http://www.waterboards.ca.gov/waterrights/water_issues/programs/bay_delta/california_waterfix/exhibits/docs/SHR/SHR-350.pdf

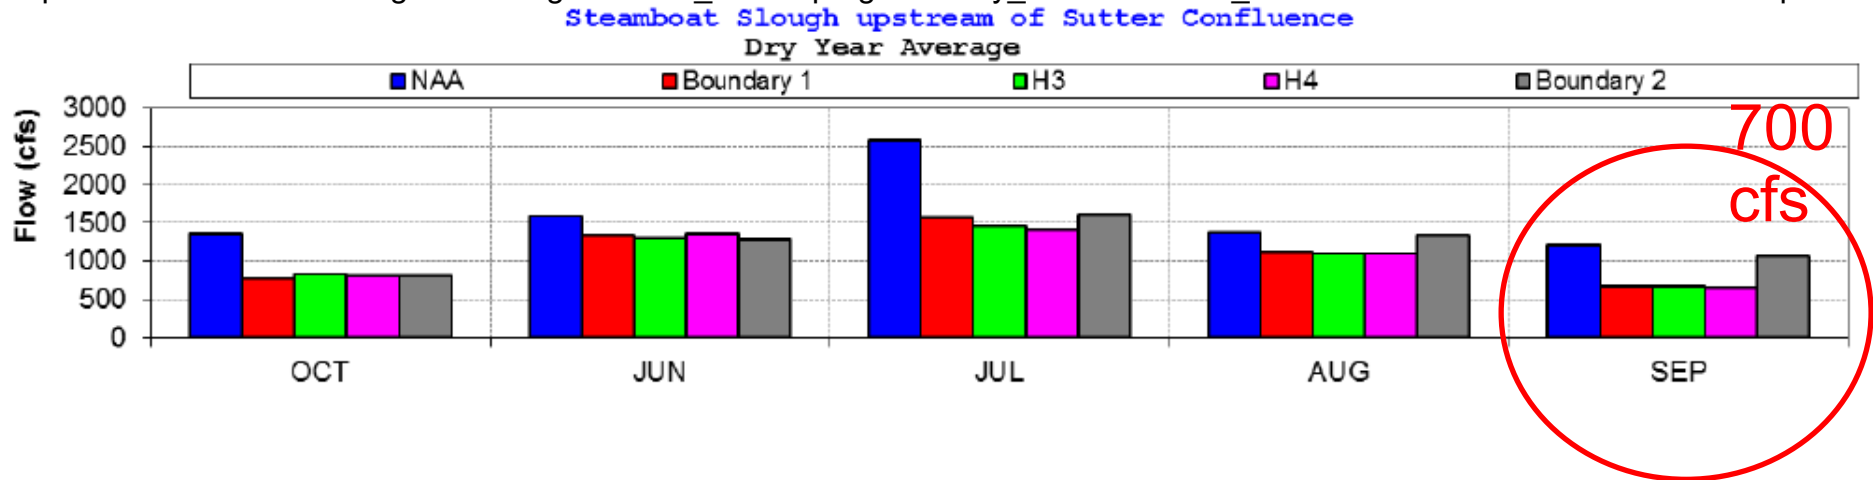
1. Do you recognize this graphic? Is it your understanding that it represents projected flows in the North Delta during a Dry Year if proposed WaterFix North Delta diversions were operational?
2. Based upon DWR modeling, for Waterfix, in a Dry Year, in September there would be no less than 700cfs of flow on Steamboat Slough past the gage labeled SSS which would result in EC no higher than 180 at the NDWA Steamboat Slough compliance station labeled SUS. Is this a correct statement based upon DWR modeling?
